Project As-Built Drawings have been reviewed by the Project Engineer and represent to the best of my knowledge, the project as constructed.
PE *[Signature]* Date 6/09

JNU-MONTANA CK/SKATERS CABIN ROAD IMPROVEMENTS
STP-000S(520) ~ 68340 &
WEST GLACIER TRAIL PARKING LOT - STAGE I
U.S. FORST SERVICE ROAD 8453 - STAGE II
PROJECT NO. 68872

DESIGNED BY: T. REED
DRAWN BY: OSBURN/BENNETT
STATE OF ALASKA
DEPARTMENT OF TRANSPORTATION & PUBLIC FACILITIES
STATEWIDE DESIGN & ENGINEERING SERVICES DIVISION
JNU-MONTANA CK/SKATERS CABIN ROAD IMPROVEMENTS

Plan & Profile

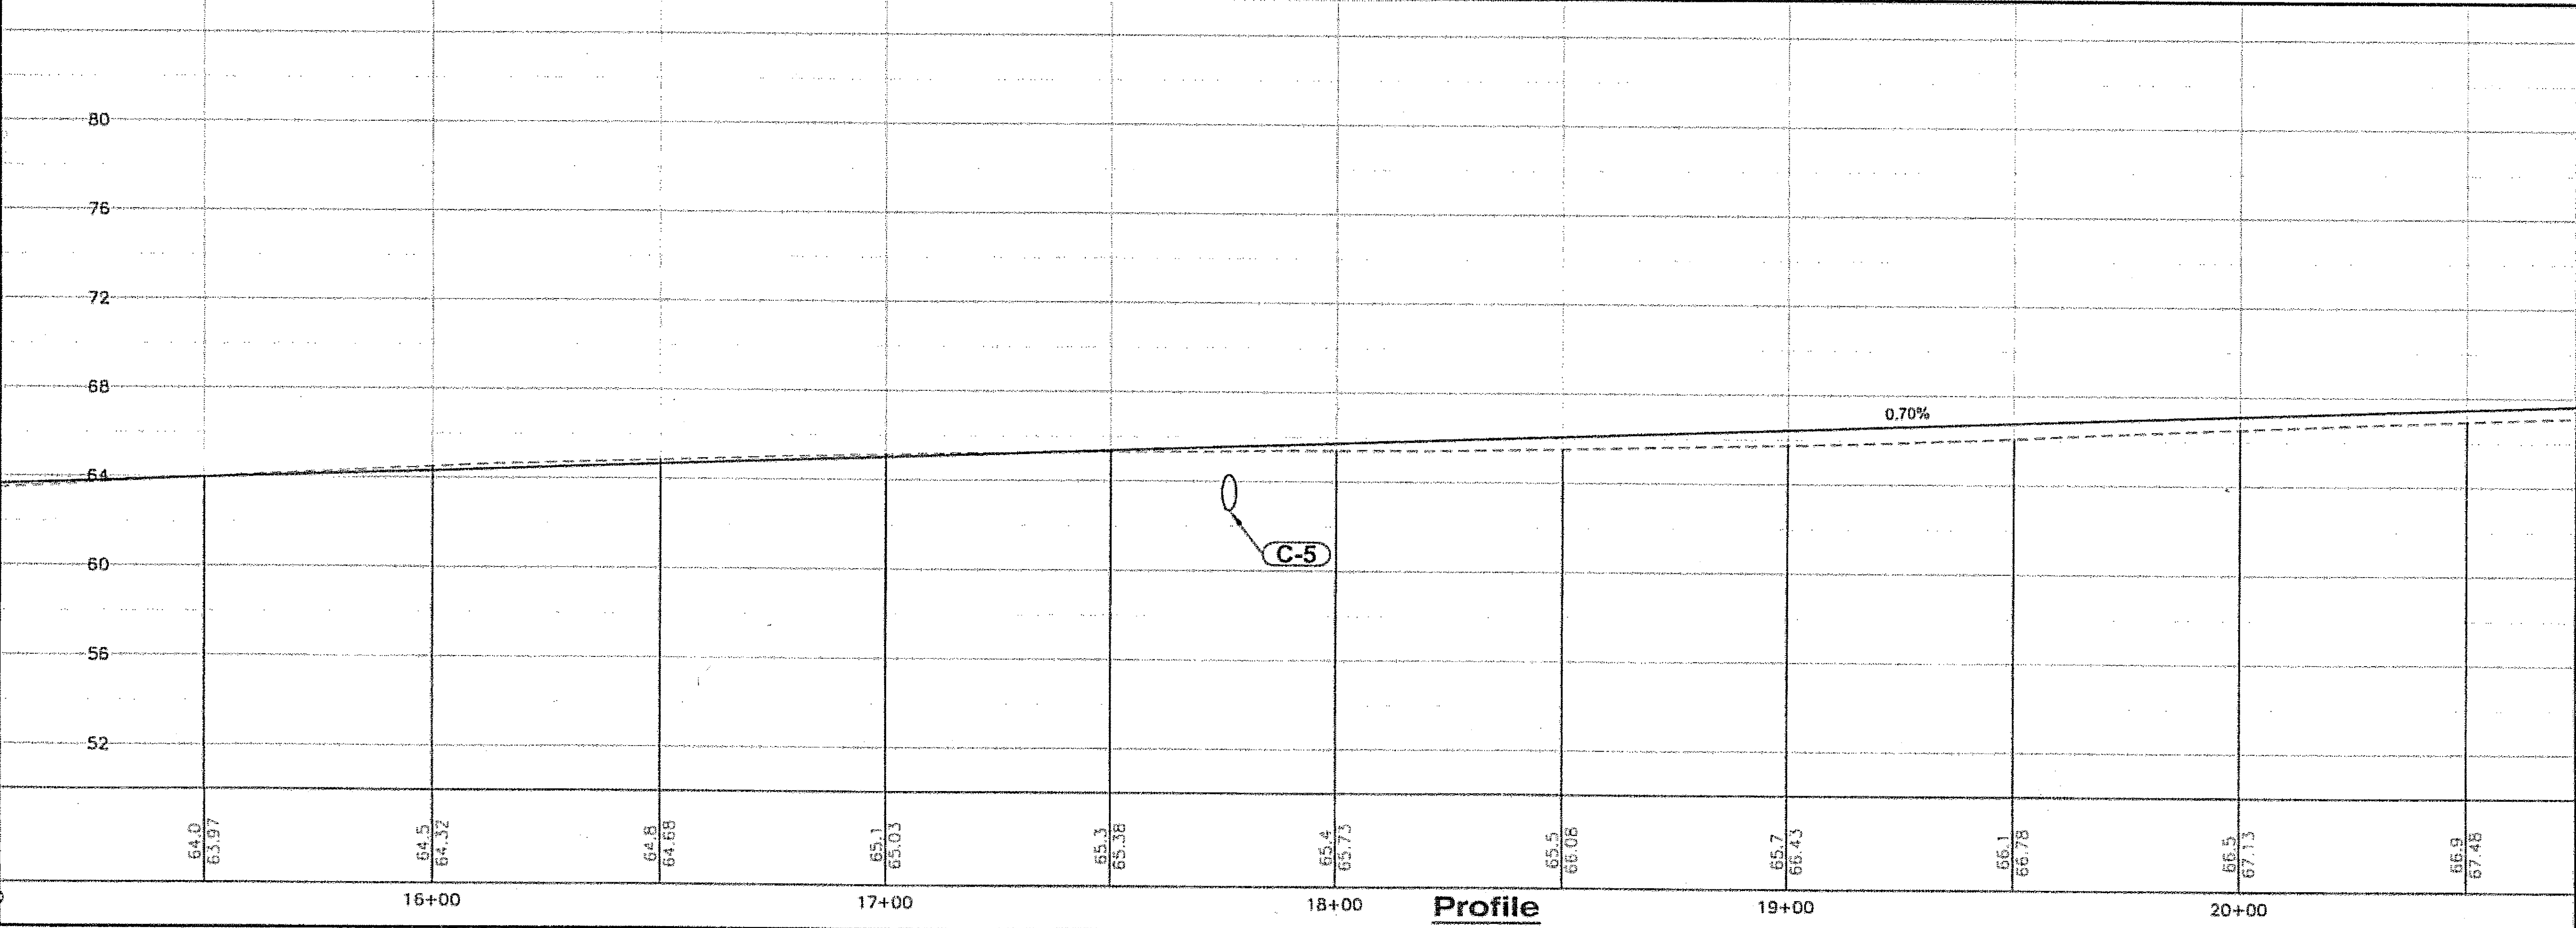
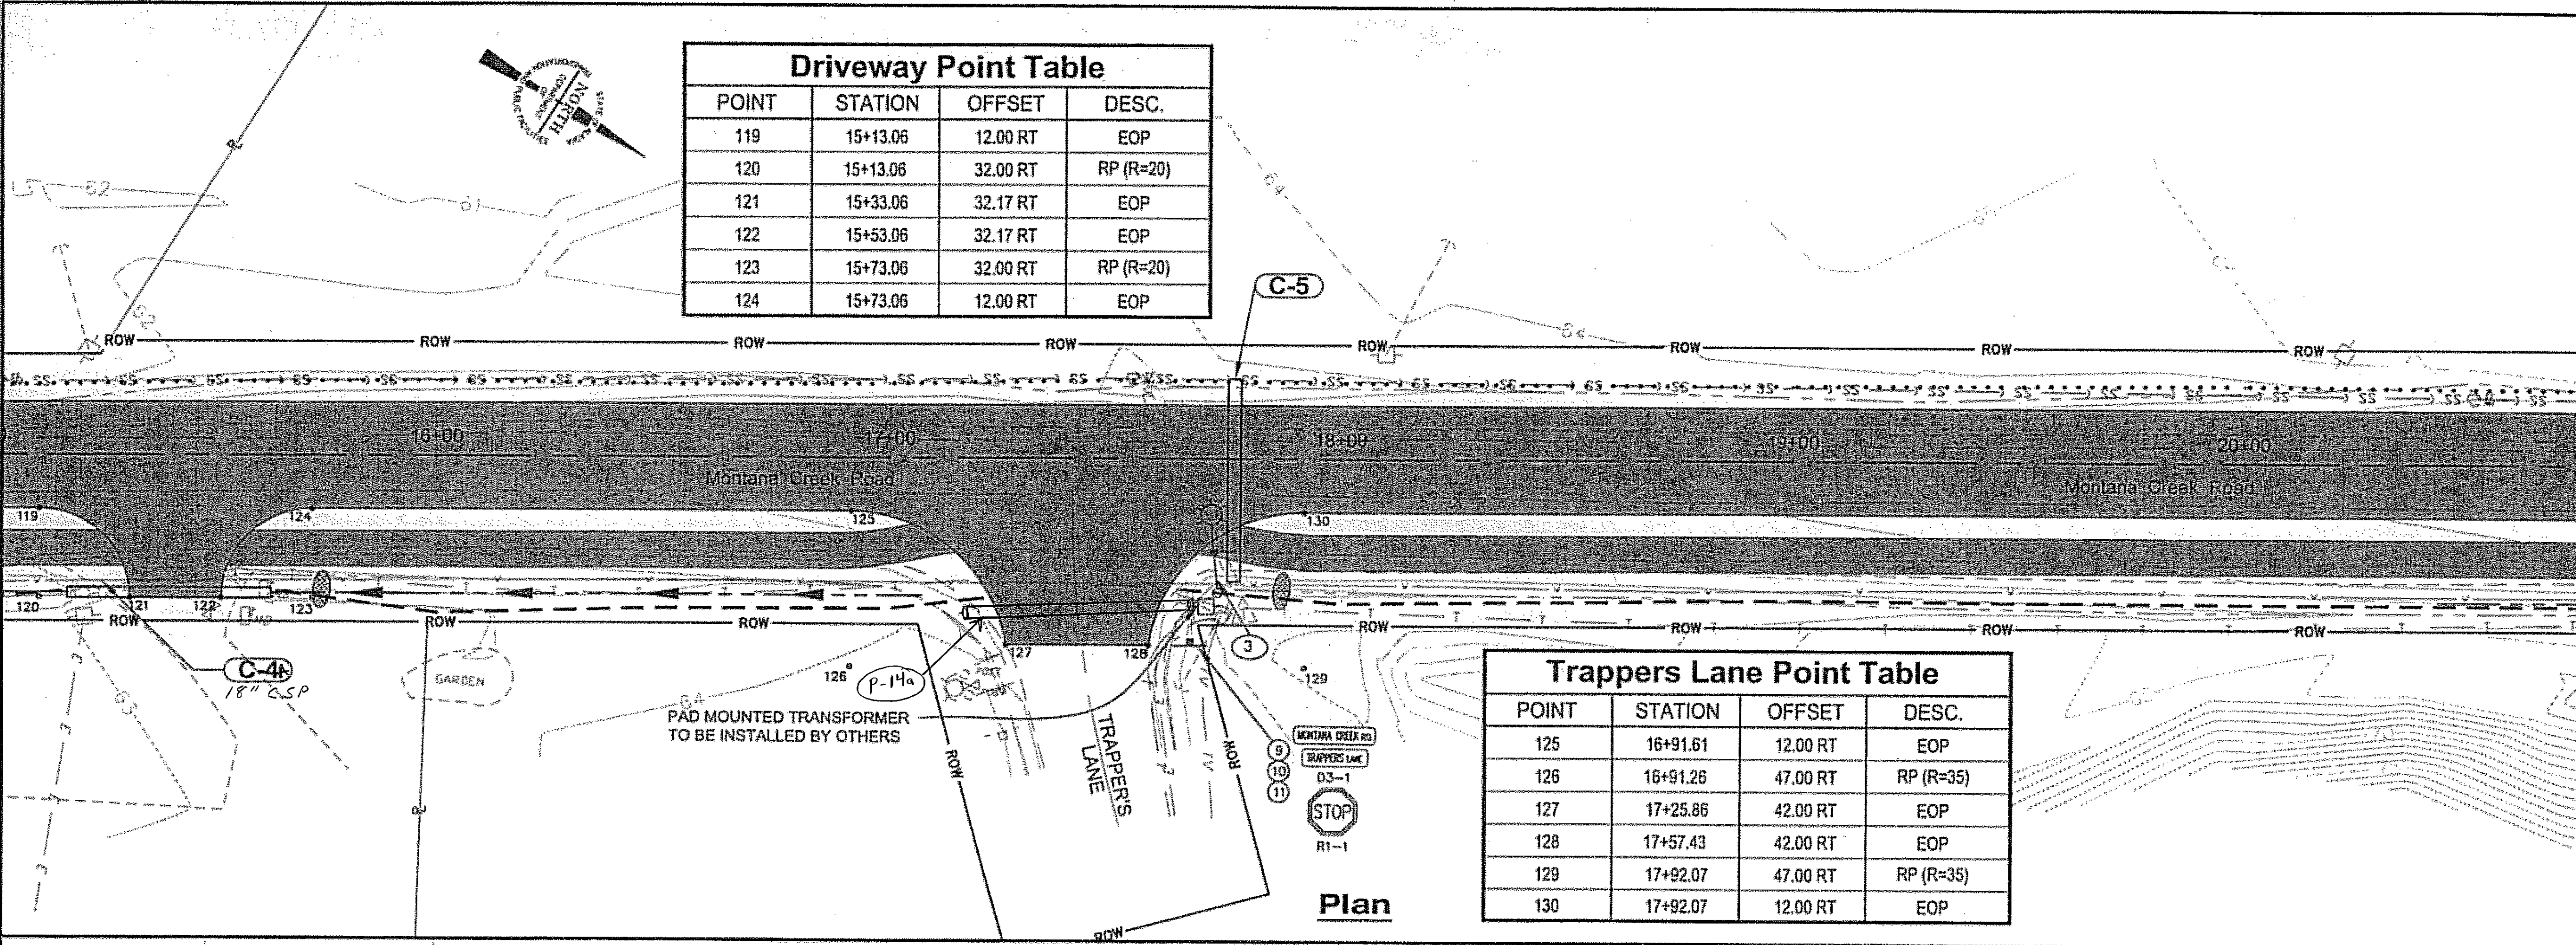
608(3)
Asphalt Sidewalk
Realignment
C.O. 41

LEGEND FOR REVISED
PATHWAY

PATHWAY AS
CONSTRUCTED

REVISED
PATHWAY
